Subject: Oyster Creek Nuclear Generating Station  
Docket No. 50-219  
Request for Additional Information for  
Evaluation of Safety Parameter Display  
System (SPDS)

ENCLOSURE

ISOLATION DEVICES--

Pages RIS(a)1-4 represent the method and diagrams for the RIS Digital Isolator testing and TEC(a)1-4 represent the same for the TEC Analog Isolators.

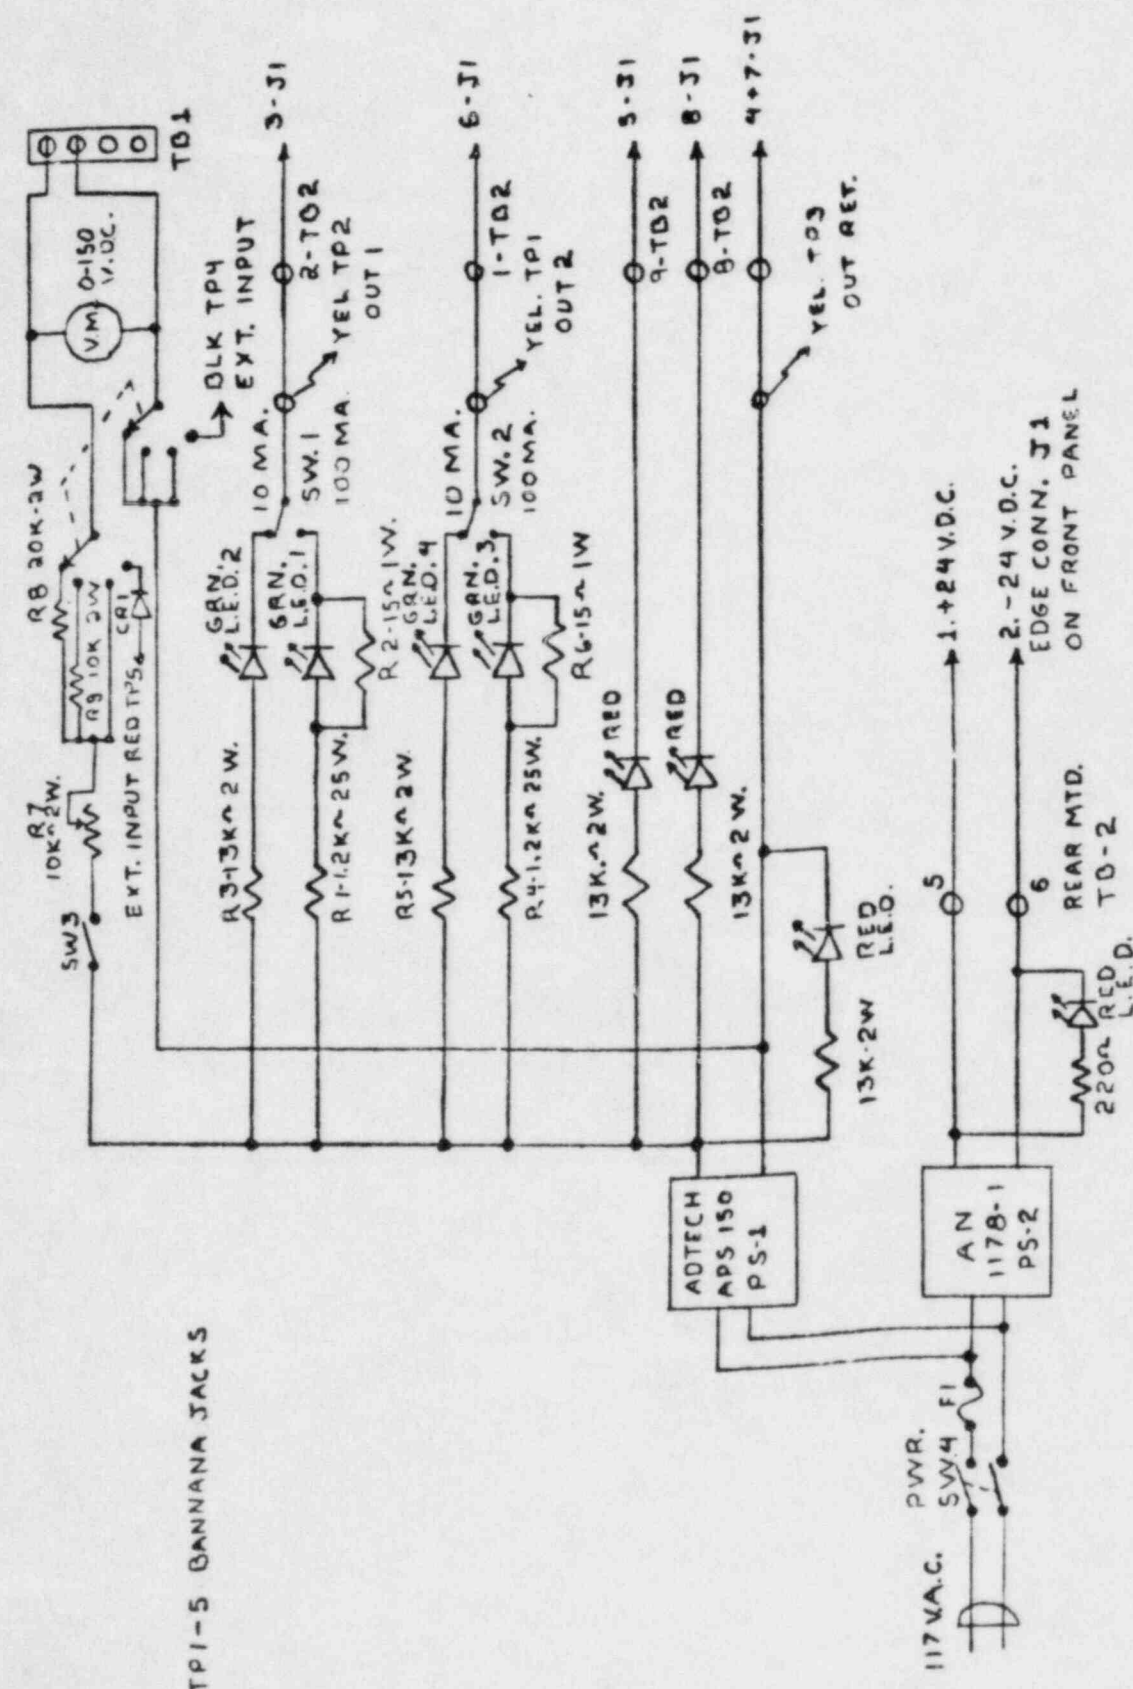
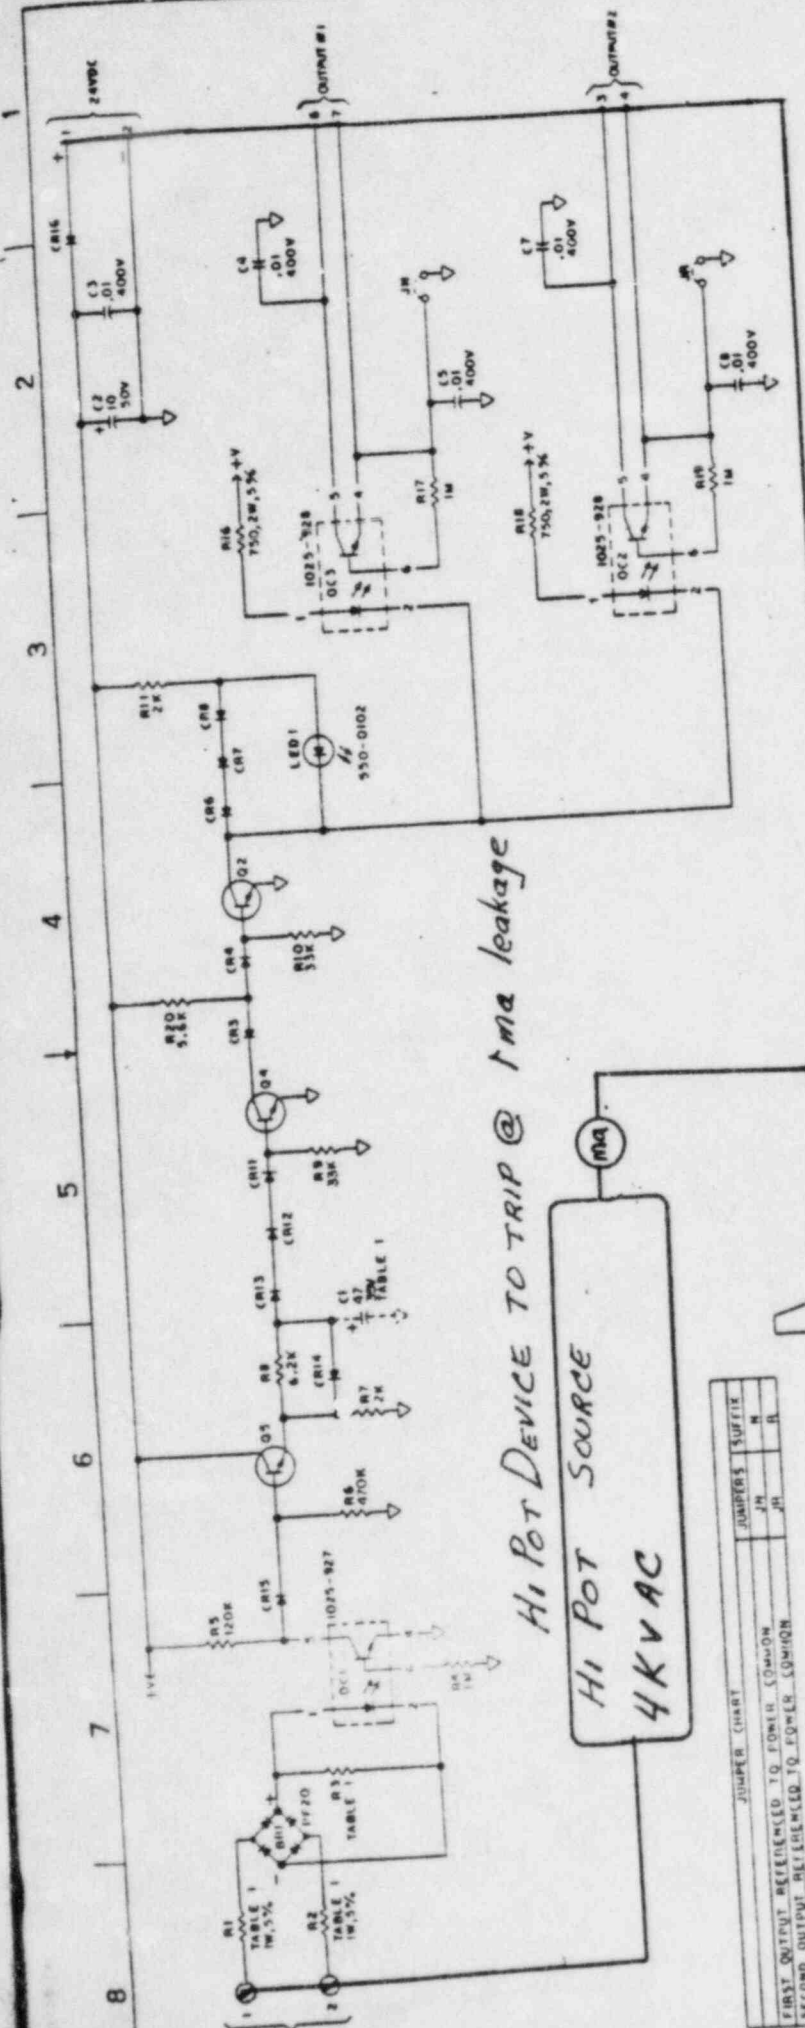
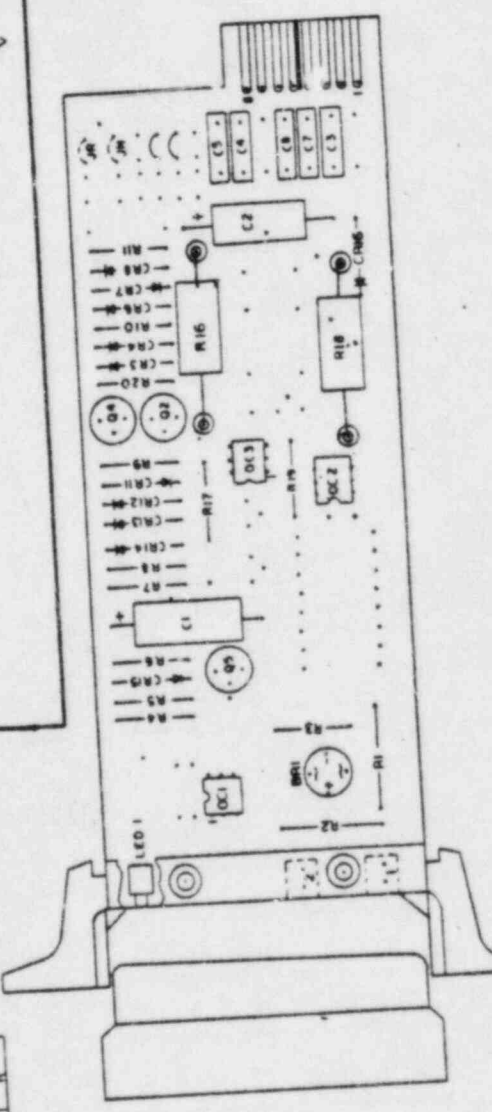
Question a: For each type of device used to accomplish electrical isolation, describe the specific testing performed to demonstrate that the device is acceptable for its application(s). This description should include elementary diagrams when necessary to indicate the test configuration and how the maximum credible faults were applied to the devices.

Response: Types of Devices Used:

Class 1E: TEC Analog Isolators  
Reference TEC Qualification Test Report No.  
31041-QP-01  
and Appendices A through I  
Isolation Scheme: Transformer Isolation

Class 1E: RIS Digital Isolators  
Reference RIS Qualification Test Report No.  
A-357-81  
Isolation Scheme: Optical Isolator

Find herein, excerpts from the vendors qualification tests for electrical isolation. These excerpts are not intended to exhaustively represent the contents of the referenced qualification efforts.

Apply 4000 VAC RMS between input and output with a 1 ma trip point. Verify and record successful testing of the module.
